7-1– 12

504.5.1, 701.1.2 (NEW), 703.2.1.1 (New), 703.2.1.2 (New), 703.5.3.1 (New), 703.5.3.2 (New), 703.6.3.1 (New), 703.6.3.2 (New), 705.3

Proponent: Sharon Toji, Access Communication, representing self

TABLE 703.2.4—VISUAL CHARACTER HEIGHT

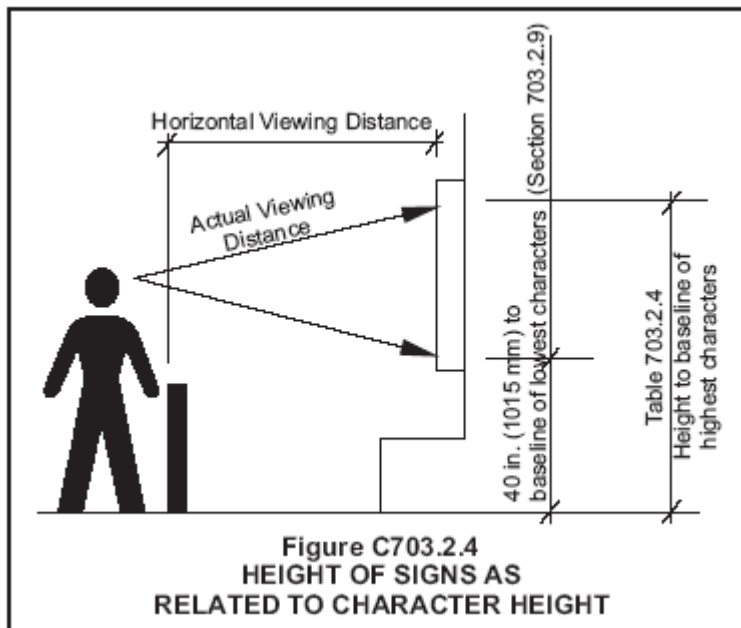
(Table 703.2.4) This proposal will clarify how the provisions are to be applied. Primarily the major revision needed is shown in footnote 1 of the table. If the committee desired, this footnote could be removed and the heading of the first column could be revised to read "Height above floor to baseline of characters on the highest line". Section 703.2.9 states that the minimum 40 inch height is "measured to the baseline of the character." That is acceptable since it is a minimum height requirement. That text does not however explain whether the ranges in the table (40 to 70, 70 to 120, or >120) is for the highest, lowest, average or each individual line of text. Therefore footnote 1 will clarify how the measurement is to be made and completes the information that is needed to comply with Section 703.2.9 which indicates "Heights shall comply with Table 703.2.4, based on the size of the characters on the sign". (Section 703.2.9 measures the minimum height to the lowest line of characters while Table 703.2.4 is measuring to the highest line of information when determining the minimum character heights.)

The following figure from the A117.1 commentary will help explain the intent of the change. It should also be noted that the commentary explaining Table 703.2.4 indicates the vertical height measurement to be used for determining the character height is taken "to the baseline of the highest line of the characters."

Height above Floor to Baseline of Character ¹	Horizontal Viewing Distance ²	Minimum Character Height
40 inches (1015 mm) to less than or equal to 70 inches (1780 mm)	Less than 6 feet (1830 mm)	⁵ / ₈ inch (16 mm)
	6 feet (1830 mm) and greater	⁵ / ₈ inch (16 mm), plus ¹ / ₈ inch (3.2 mm) per foot (305 mm) of viewing distance above 6 feet (1830 mm)
Greater than 70 inches (1780 mm) to less than or equal to 120 inches (3050 mm)	Less than 15 feet (4570 mm)	2 inches (51 mm)
	15 feet (4570 mm) and greater	2 inches (51 mm), plus ¹ / ₈ inch (3.2 mm) per foot (305 mm) of viewing distance above 15 feet (4570 mm)
Greater than 120 inches (3050 mm)	Less than 21 feet (6400 mm)	3 inches (75 mm)
	21 feet (6400 mm) and greater	3 inches (75 mm), plus ¹ / ₈ inch (3.2 mm) per foot (305 mm) of viewing distance above 21 feet (6400 mm)

1. The vertical height is measured from the floor of the viewing position to the baseline of the highest line of characters.
2. The horizontal viewing distance shall be measured as the horizontal distance between the character and an obstruction preventing further approach towards the sign or where applicable, as stated in the exception to Section 703.2.4.

TABLE 703.7.4—LOW RESOLUTION VMS CHARACTER HEIGHT

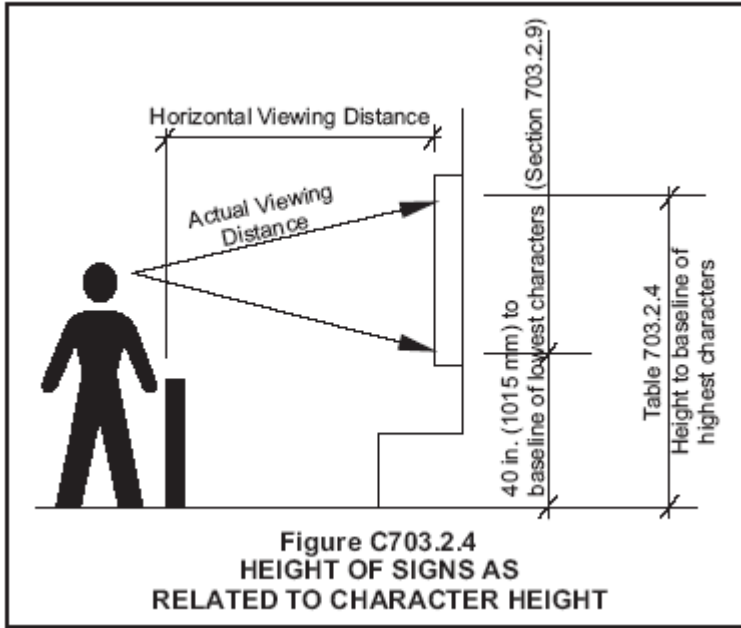
(Table 703.7.4) This proposal will clarify how the provisions are to be applied. Primarily the major revision needed is shown in footnote 1 of the table. If the committee desired, this footnote could be removed and the heading of the first column could be revised to read "Height above floor to baseline of characters on the highest line". Section 703.7.9 states that the minimum 40 inch height is "measured to the baseline of the character." That is acceptable since it is a minimum height requirement. That text does not however explain whether the ranges in the table (40 to 70, 70 to 120, or >120) is for the highest, lowest, average or each individual line of text. Therefore footnote 1 will clarify how the measurement is to be made and completes the information that is needed to comply with Section 703.7.9 which indicates "Heights of low resolution variable message signs characters shall comply with Table 703.7.4, based on the size of the characters on the sign". (Section 703.7.9 measures the minimum height to the lowest line of characters while Table 703.2.4 is measuring to the highest line of information when determining the minimum character heights.)

The following figure from the A117.1 commentary will help explain the intent of the change. It should also be noted that the commentary explaining Table 703.2.4 indicates the vertical height measurement to be used for determining the character height is taken "to the baseline of the highest line of the characters."

Height above Floor to Baseline of	Horizontal Viewing Distance ²	Minimum Character Height
40 inches (1015 mm) to less than or equal to 70 inches (1780 mm)	Less than 10 feet (3050 mm)	2 inches (51 mm)
	10 feet (3050 mm) and greater	2 inches (51 mm), plus 1/5 inch (5.1 mm) per foot (305 mm) of viewing distance above 10 feet (3050 mm)
Greater than 70 inches (1780 mm) to less than or equal to 120 inches (3050 mm)	Less than 15 feet (4570 mm)	3 inches (75 mm)
	15 feet (4570 mm) and greater	3 inches (75 mm), plus 1/5 inch (5.1 mm) per foot (305 mm) of viewing distance above 15 feet (4570 mm)
Greater than 120 inches (3050 mm)	Less than 20 feet (6095 mm)	4 inches (100 mm)
	20 feet (6095 mm) and greater	4 inches (100 mm), plus 1/5 inch (5.1 mm) per foot (305 mm) of viewing distance above 20 feet

1. The vertical height is measured from the floor of the viewing position to the baseline of the highest line of characters.
2. The horizontal viewing distance shall be measured as the horizontal distance between the character and an obstruction preventing further approach towards the sign or where applicable, as stated in the exception to Section 703.7.4.
